PLANNING NMA-CHANGE LIST		
ID	Proposed Changes to plans that are 'Non Material'	Reason for 'Amendment'
A	Changes to Common stair towards compliance for general access where a clear landing needs to be provided and to accommodate smoke control. Circulation area and internal doorway to stairs rearranged to adapt corridor aisle. Stairs, structurally stacked for construction leading towards the corridor or lobby next to the stair being provided with a smoke vent and a store area provision on ground level. Rearrangement in plan due to the above visible on the Northeast facade. Window openings, adapted to suit mentioned changes/rearrangement.	Compliance towards Building Regulations, Part-K-Protection from falling, collision and impact and Part-B-Fire safety
B	Changes to Communal lifts and stairs towards compliance for firefighting where a firefighting shaft is required as the building is over 18m and to accommodate smoke control and building services. Circulation area internal doorway to stairs and clear landing for lifts rearranged to adapt corridor aisle. Stairs, structurally stacked for construction leading towards a vertical smoke shaft that opens at roof level with rationalised comm

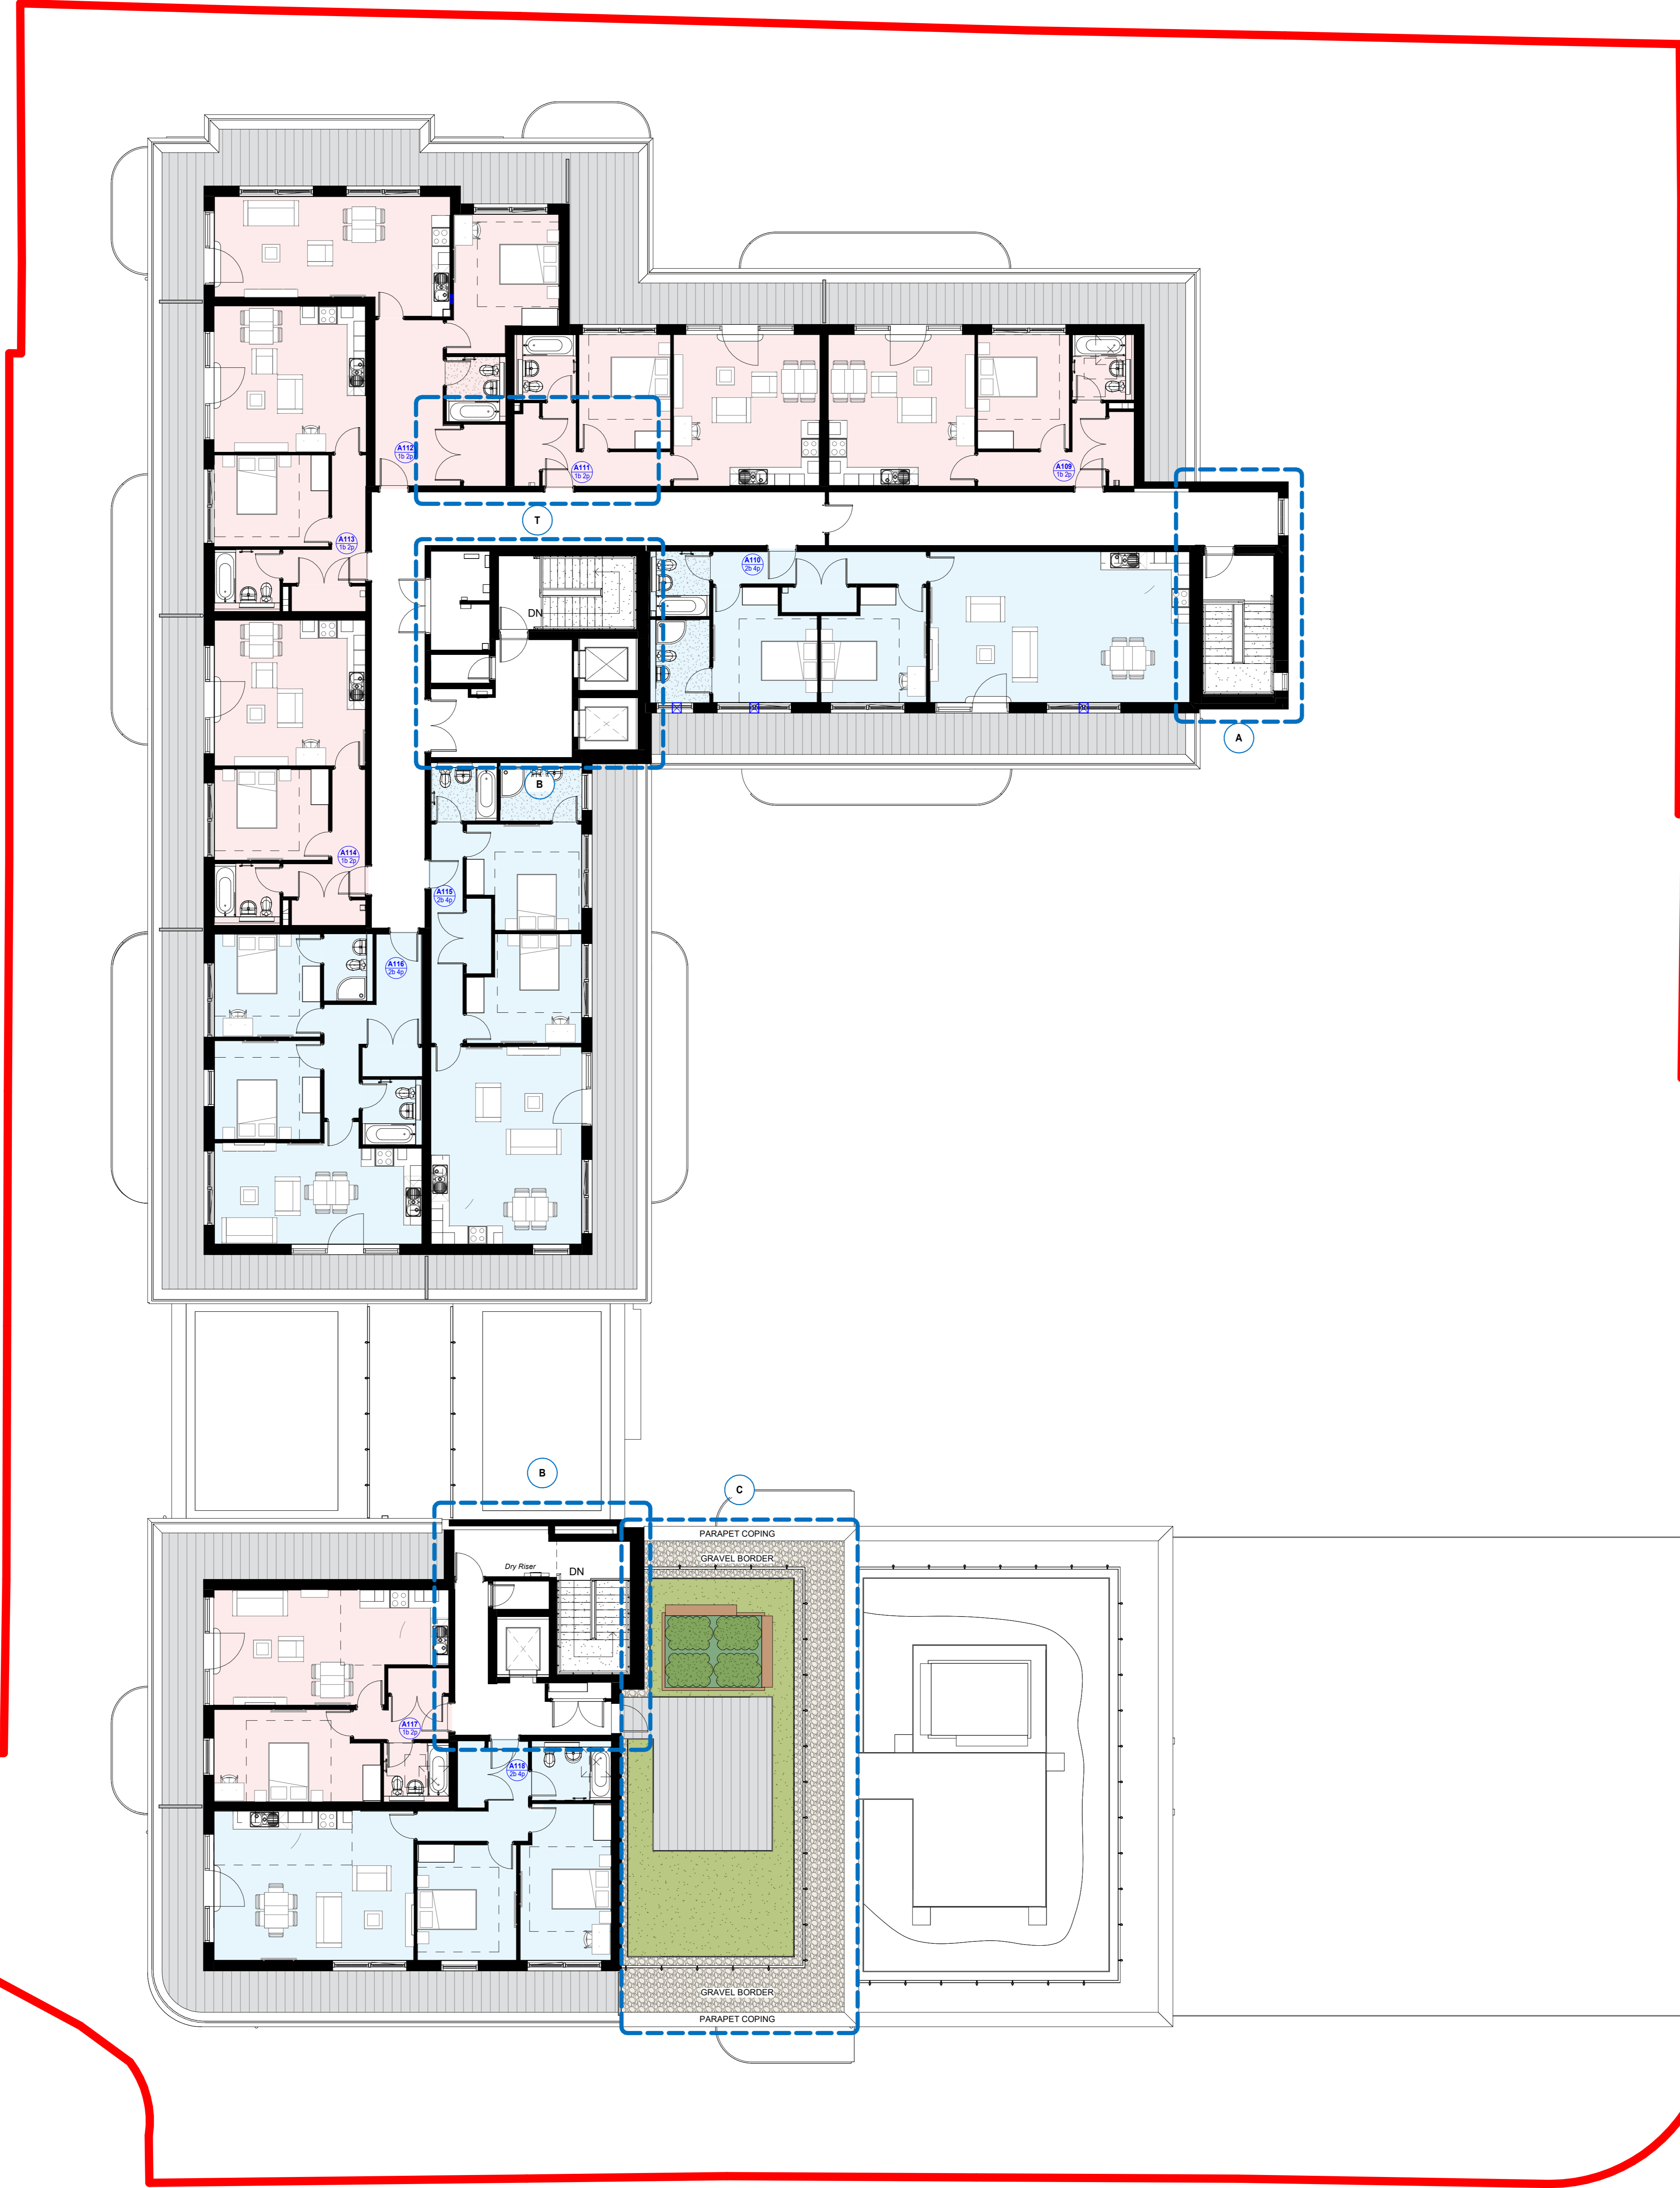
C	Changes to communal roof gardens (landscaping) including change of barrier type (railing) from glazed balustrade to counterbalance metal railing.	To contribute positively towards biodiversity via balance of soft and hard landscaping schemes including provisions for bird and bat boxes, whilst maintaining overall uniformity for railing type
D	Removal of photovoltaic (PV) cells on the roof	PV was not required as Part L requirement was met using Exhaust Air Heat Pumps
E	Relocation of Substation and provision for Generator in allocated space.	Provision for separate secluded area for generator
F	Changes to provide new location for UKPN Substation	Provision for future relocation for UKPN Substation
G	Changes to ground level Cycle store to accommodate building services plant rooms including removal of two openings with rearrangement of the remainder openings.	Provision towards Building Services, Secondary LV switch room and Comms room.

H	Changes to ground level Cycle store to accommodate building services plant rooms including removal of two openings with rearrangement of the remainder openings.	Provision towards secure access and splitting into 4 small bin stores to comply with recent updates of having maximum 8 large (1100lrs) receptacles within.
J	Removal of Cycle store area and Bin store area at ground level, including external door in cycle store area towards provision to accommodate building services plant room including clear vehicular access towards undercroft parking.	Provision towards Building Services, Primary LV switch room and vehicular access towards undercroft parking.
K	Changes to ground level facade including removal of two openings to accommodate communal letter boxes with rearrangement of the remainder openings with provision for accessibility.	Provision towards communal letter boxes
L	Removal of undercroft parking entrance/exit at ground level towards provision for Relocation/Retainment of existing UKPN Substation, whilst adding double doors as per change ID C-05.	Provision towards single point of entry/exit for undercroft parking and towards relocation/retainment of existing UKPN Substation mentioned in change ID-E.

M	Changes to ground and first floor level, Common stair for means of fire escape and to accommodate smoke control to circulation area. Circulation area and internal doorway to stairs rearranged to adapt corridor aisle. Stairs, moved away from corridor aisle leading towards provision for an external smoke vent at first floor level. Rearrangement in plan due to the above visible on the Northeast facade. Ground level escape door, adapted to suit mentioned changes/rearrangement.	Compliance towards Building Regulations, Part-B-Fire safety.
N	Changes to ground level Cycle room and adjacent Store to replace provision for Cycle store area as per change ID C-09 via consolidation. Rearrangement in plan due to the above visible on elevations.	Provision towards replacement of removed cycle store mentioned in change ID-J.
P	Changes to Communal lift and stairs towards compliance for general access where a clear landing needs to be provided and to accommodate smoke control and building services. Circulation area internal doorway to stairs and clear landing for lifts rearranged to adapt corridor aisle. Stairs, structurally stacked for construction leading towards covered and enclosed stair at roof fourth floor level with rationalised communal entrance/exit. Rearrangement in plan due to the above visible on elevations.	Compliance towards Building Regulations, Part-K-Protection from falling, collision and impact, Part-B-Fire safety and Provision for stair enclosed/walkway that is directly covered.

Q	Changes to ground level Bin store arrangement to replace Bin store as per change ID C-09 via consolidation and enlargement to provide building services plant room. Rearrangement in plan due to the above visible on elevations.	Provision towards replacement of removed Bin store mentioned in change ID-J and provision for BCW Tank room
R	Changes to ground level openings, facade screens from circular pattern metal screens/vents to vertical extruded aluminium flats metal screen that match the railing type, including removal of one opening that clashes structural column on the corner way elevation.	To maintaining overall architectural uniformity and structural framing.
S	Removal of Green Wall as they do not comply with fire safety regulation 7(2).	Regulation 7(2), requires all residential blocks with top storey heights over 18m to have all materials which become part of an external wall or specified attachment (e.g., balconies) to achieve class A2-s1, d0 or class A1, except for materials which are exempt as per regulation 7(3). Additionally, membranes used as part of external wall construction above ground should achieve a minimum of class B-s3, d0.

T	Changes to storage area, rearrangement towards desired storage required.	Provision towards desired storage required.
U	Discrepancy error on Comet way elevation whereby two window openings depicted would not have been located on the fifth-floor level plan as these would intrude privacy for the bathrooms.	Discrepancy error
V	Removal of single window, recessed brick reveals on the Northeast elevation.	The recessed brick reveals is towards the left of a single pane window for levels 1-4, whilst it changes to a double pane for level 5. To maintain architectural uniformity, we have detailed a constant double pane window for all levels.
X	Private path on western site boundary	For Façade maintenance MEWP access.
